**NOTICE OF ADDENDUM
ADDENDUM NO. 2**

**CONTRACT NO. 7939
MADISON MUNICIPAL BUILDING - RENOVATION**

This addendum is issued to modify, explain or correct the original Drawings, Specifications, or Contract Documents and is hereby made a part of the contract documents.

1 LEVEL 2 EXISTING HISTORIC WINDOW FOR REFERENCE
A621 1/2" = 1'-0"

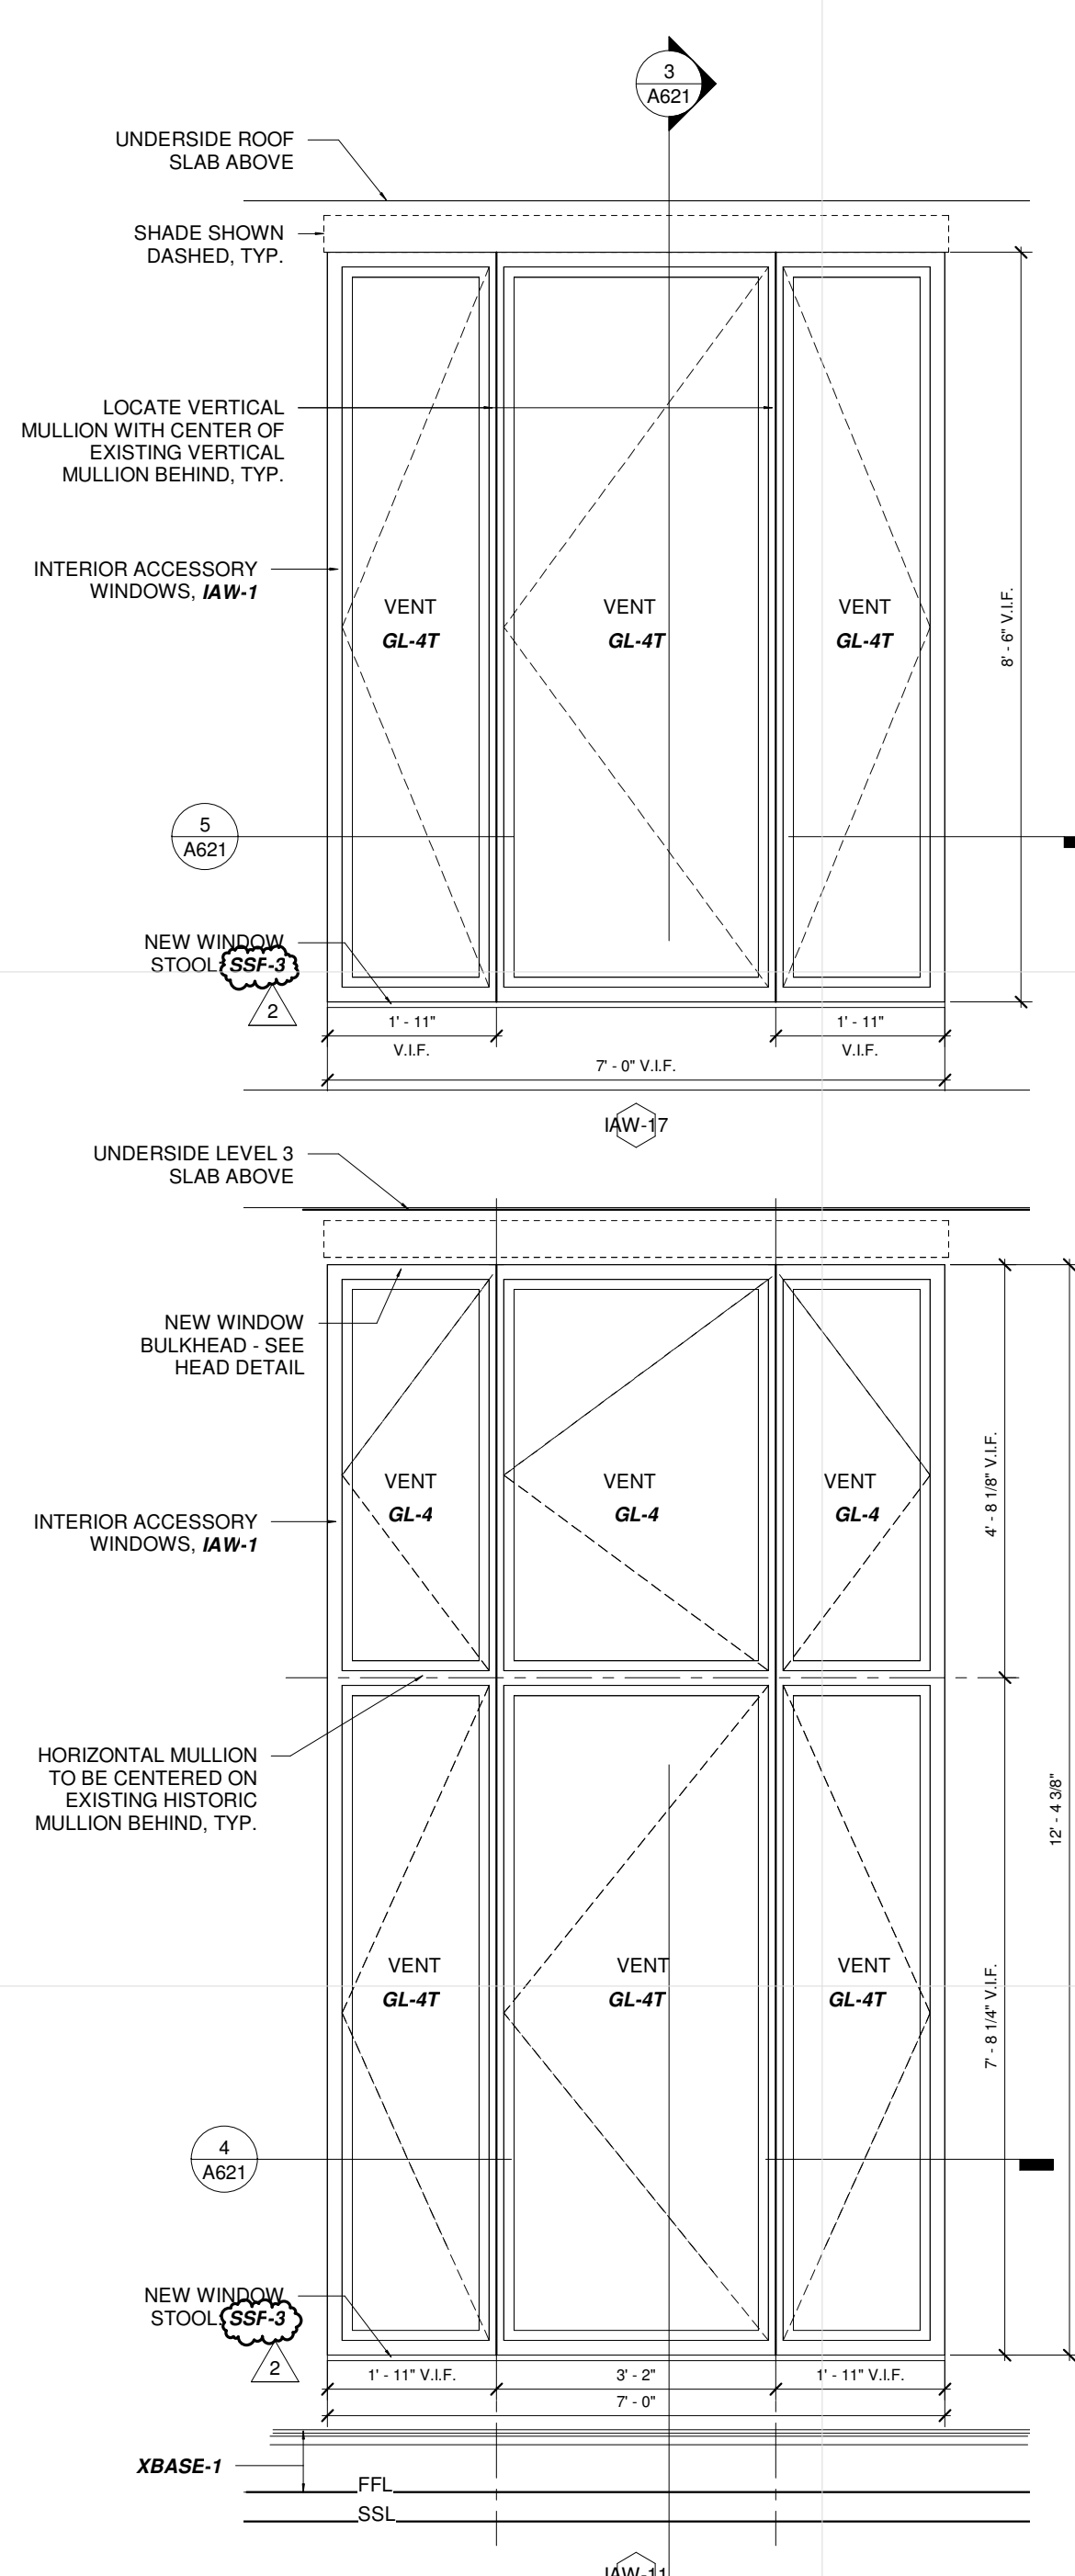
4. Details A620 through A624, and A651 through A654. Due to durability and cost concerns regarding the new metal window stools, these have been changed from MTL-3 to solid surface material SSF-3.
5. BE001. Amend general note 10 on sheet BE001 (drawing); Add language to general note 16 on sheet BE001 (drawing)
6. BE219. Revised stone numbers
7. BE338. See Clarifications Section below
8. BE356. See Clarifications Section Below
9. BE356.1. See Clarifications Section Below
10. BE356.2. See Clarifications Section Below
11. S101. See Structural Memo Attached.
12. S102. See Structural Memo Attached.
13. S103. See Structural Memo Attached.
14. S104. See Structural Memo Attached.
15. S190. See Structural Memo Attached.
16. S201. See Structural Memo Attached.
17. S302. See Structural Memo Attached.
18. S304. See Structural Memo Attached.
19. E300. See MEP Memo Attached.
